URBAN COLLECTION AT PALMER VILLAGE PLAT

LETTER OF INTENT

NOVEMBER 2020

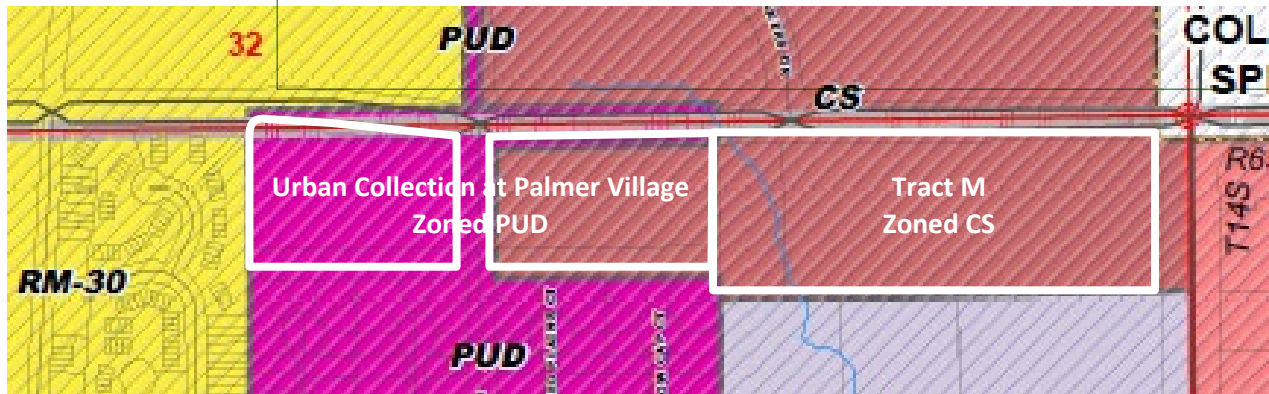
Please revise this is confusing (2 easts?) Maybe use roads or context- or show the actual zoning pud doc here since this is not accurate at all.

future dev tract
